Access Compliance Report Public Rights-of-Way (Pedestrian Signals)

Main Street: YORBA_ST Cross Street: FAIRHAVEN_AVE Location: NE

ADA ID: SGRK220126123651 Signal Type: One Push Button-Non APS Overall Compliance: No Severity Scores: BTN 1: 35 BTN 2: N/A No BTN: N/A

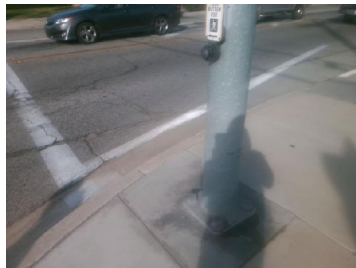
OC Std/PROW: R404.2, R404.3, MUTCD 4e.08

Possible Solutions: Replace Signal Push Button With APS Button. Remove and Replace Clear Space.
